IN THE DRAWINGS

Please amend the drawings as follows:

The attached sheets of drawings, sheets 1 through 6, include amendments to FIGs. 2, 3, 4, 7, 8, and 9. These sheets replace the original sheets 1 through 6.

FIG. 2

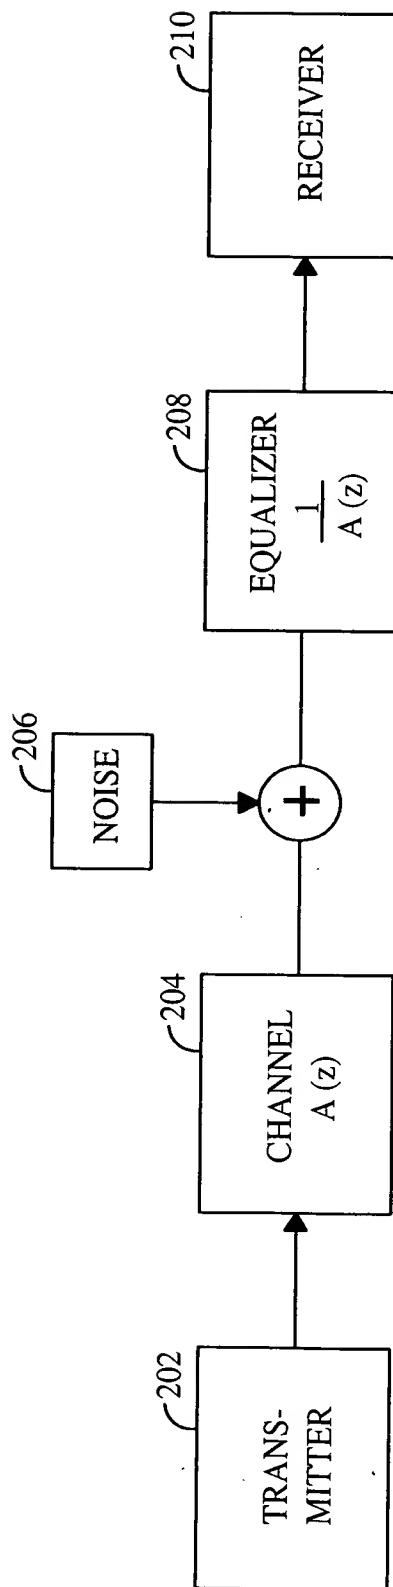
Specifically, Applicant amends FIGs. 2, 3, 4, and 9 to correct minor typographical errors. FIGs. 2, 3, and 9 have the argument of the function "A()" changed to the discrete complex variable "z" instead of the mistyped "2" in the original drawings. FIG. 9 also has the equalizer transfer functions corrected to be $H1(z)$ and $H2(z)$ consistent to the specification. FIG. 4 has the label added for communication system **400** consistent to paragraph [1028]. The name of element **412** in FIG. 4 was inadvertently omitted. This element has been labeled "controller." Paragraph [1035] in the specification as originally filed refers to "the controller **412**." Hence, this correction does not constitute new matter.

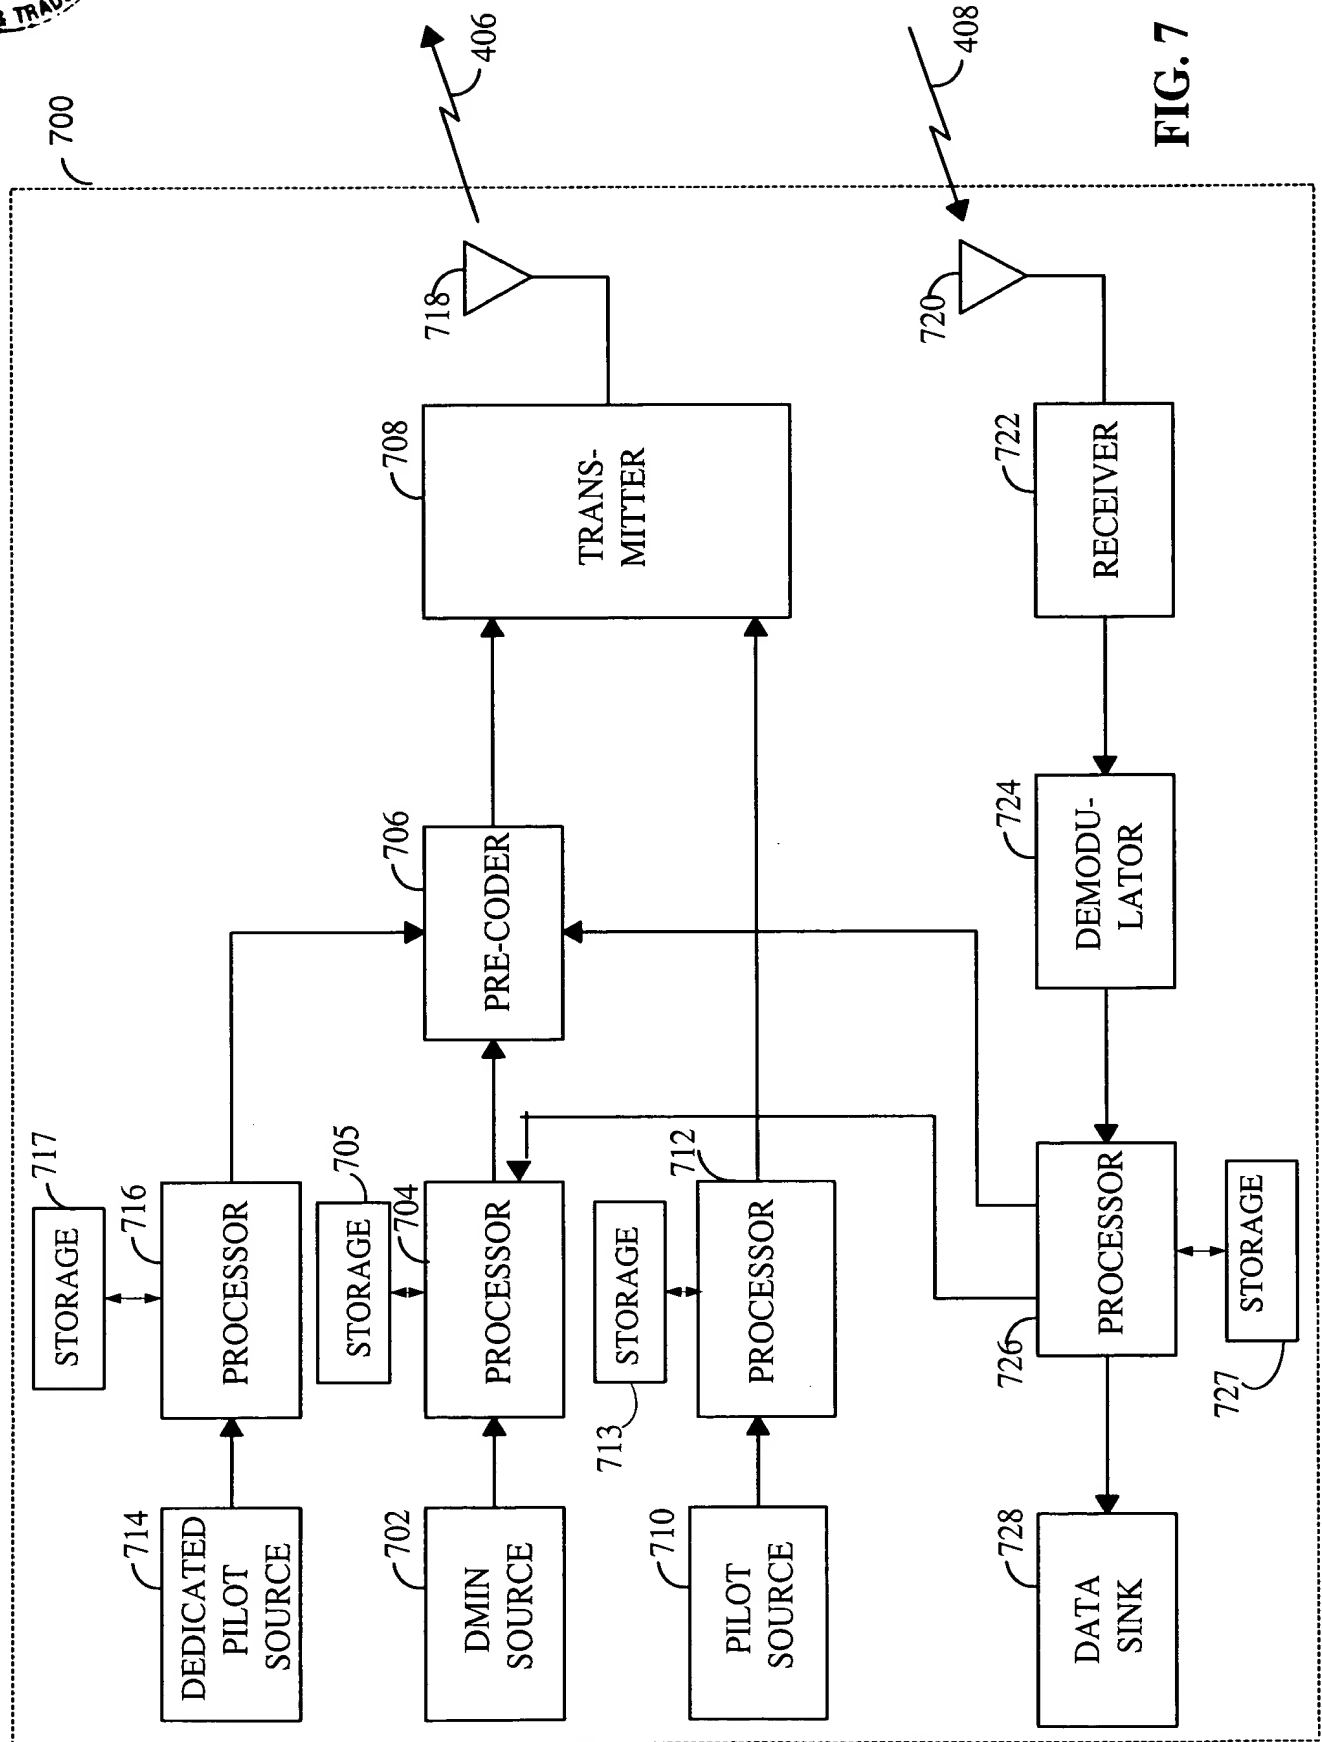
FIGs. 7 and 8 are amended to have storage attached to all processors to comply with examiner's objection that the drawings must show every feature of the invention specified in the claims. Applicant states that the addition is not new matter because digital processing and computation inherently involves some sort of storage, either separately or distributed among the processing elements, or both. Further paragraph [1059] in the original specification discusses various storages media that can be coupled to the processor.
